ADDENDA NUMBER TWO (2)

Project: Hinds Community College
Health Sciences Complex
Site Improvement Package
Rankin Campus – Pearl, MS
HCC Bid #3282
DA PN: 23029

ADDENDA NO. TWO (2) – CIVIL ENGINEERING ITEMS

Health Sciences Complex – Site Improvements Package
(Rankin Campus) Hinds Community College
(Community College Board)
Pearl, Mississippi (HCC Bid #3282)

Sheet Number:
C6.3
RETAINING WALL
DETAILS

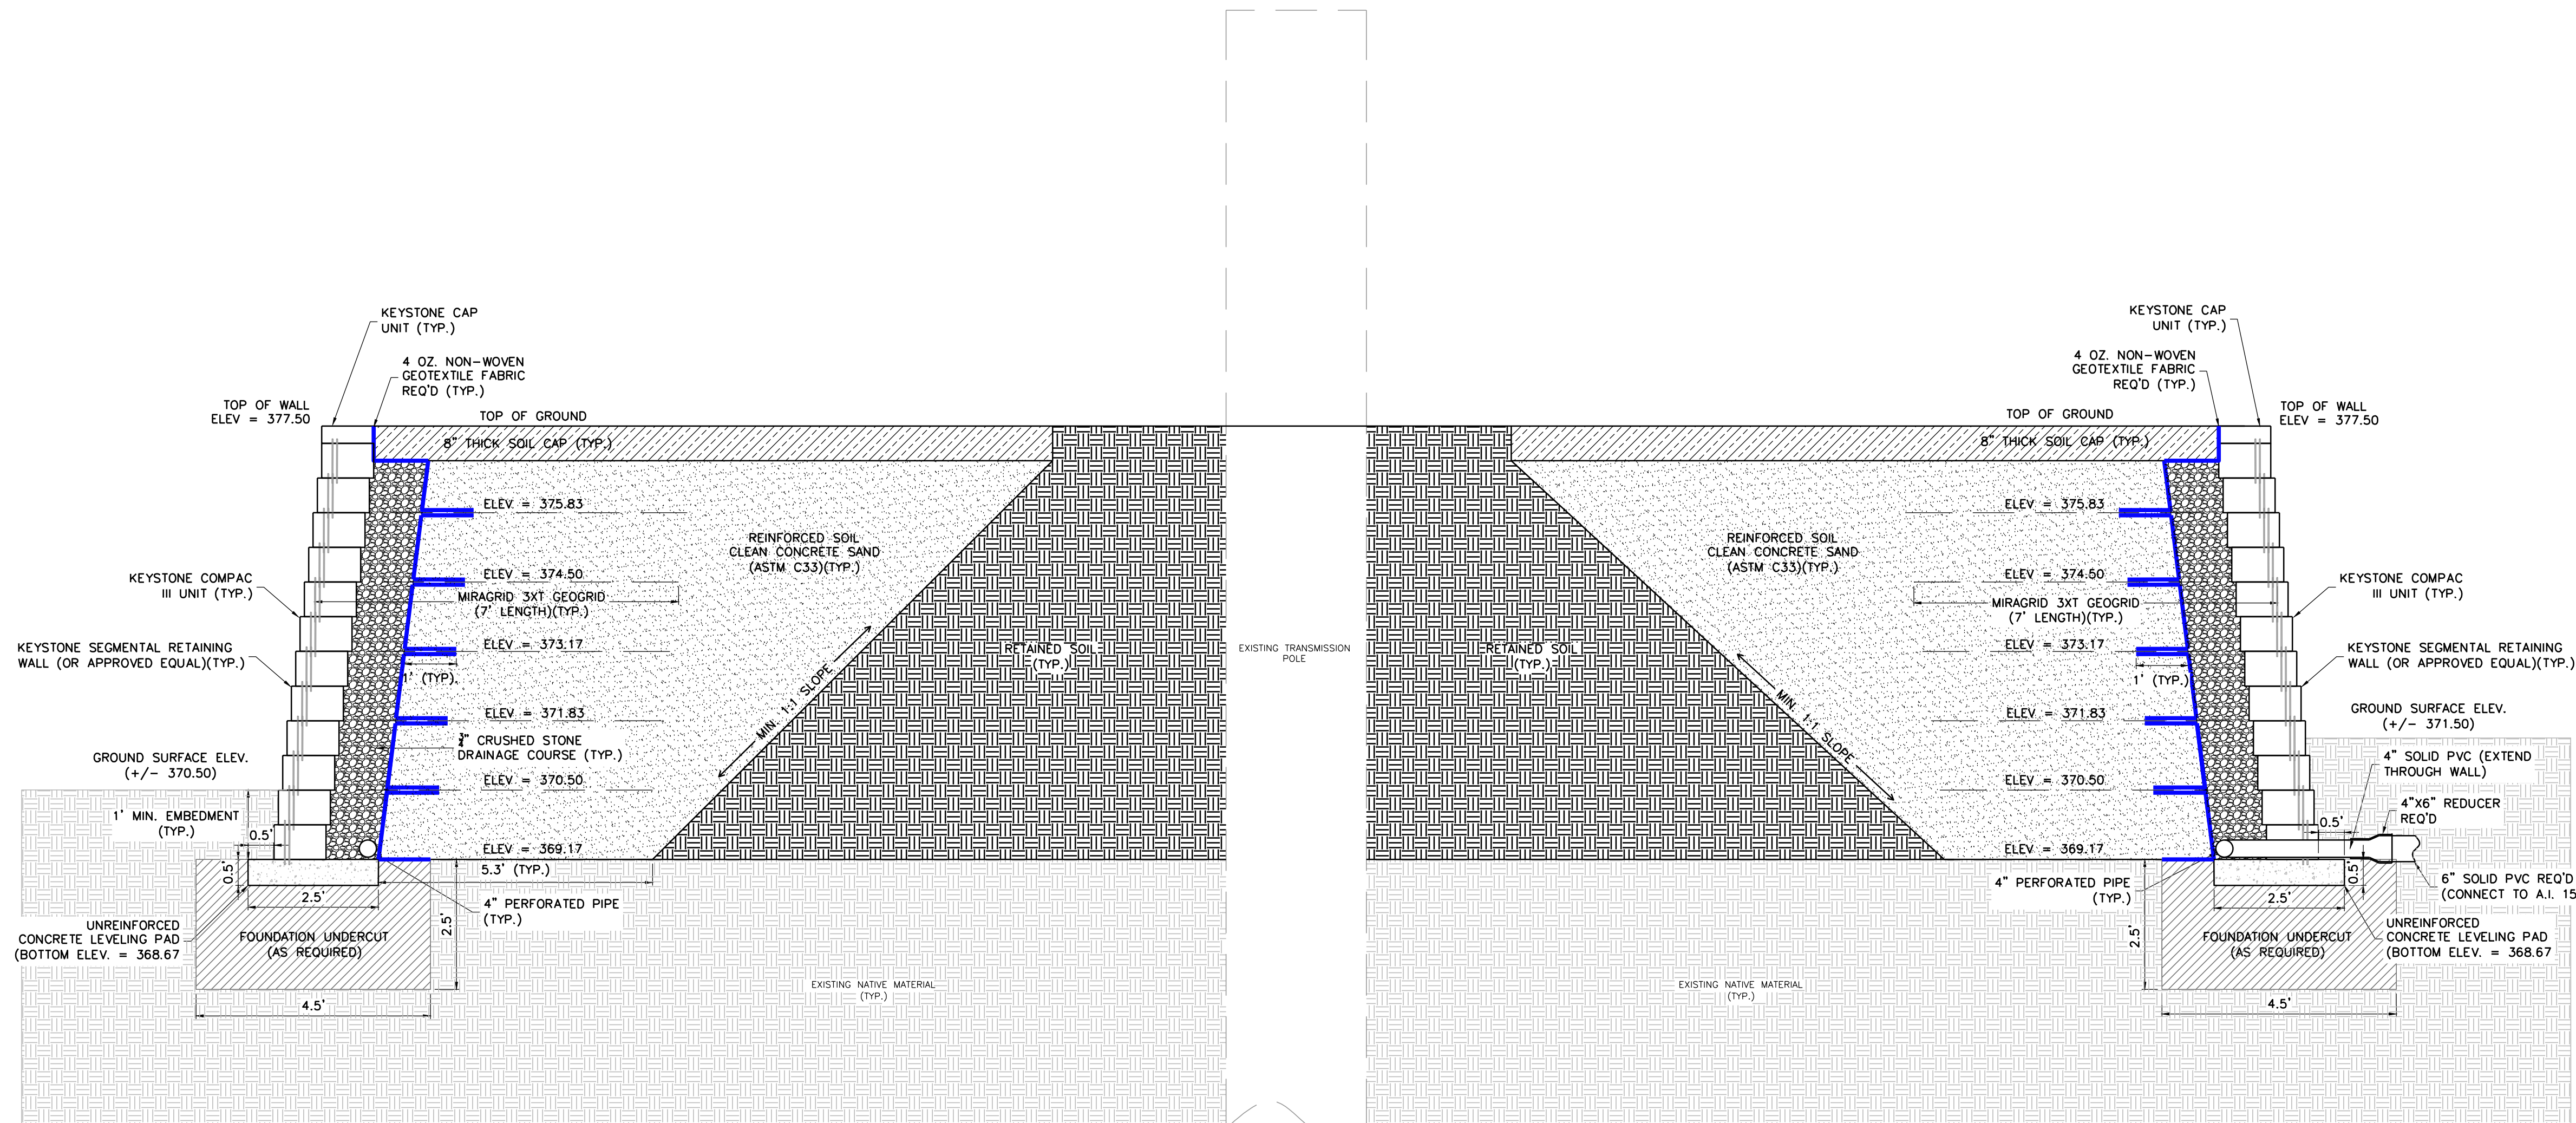
- 1.1 Item #1 – Please ensure that the contractor has spotters when working under or around the existing transmission lines/structures.
- 1.2 Item #2 – For the Retaining Wall shown on sheet C6.3. Non-reinforced concrete leveling pad is required.
- 1.3 Item #3 – There will be no sodding, only permanent seeding following final grading operations.
- 1.4 Item #4 – All P.V.C. drainage piping shall be Schedule 40.

- 1.6 The revised drawing pertaining to Addenda No. Two (2) is attached.
- 1.7 Item #1 – Replace sheet C6.3 Retaining Wall Details with revised sheet C6.3 that is attached.

7. CONTRACTOR SHALL INSTALL UNREINFORCED CONCRETE LEVELING PAD ON PREPARED, LEVEL, & COMPACTED FOUNDATION MATERIALS.
 8. CONTRACTOR SHALL ENSURE POSITIVE DRAINAGE FROM BACK OF WALL AND SURROUNDING WALL AREAS.
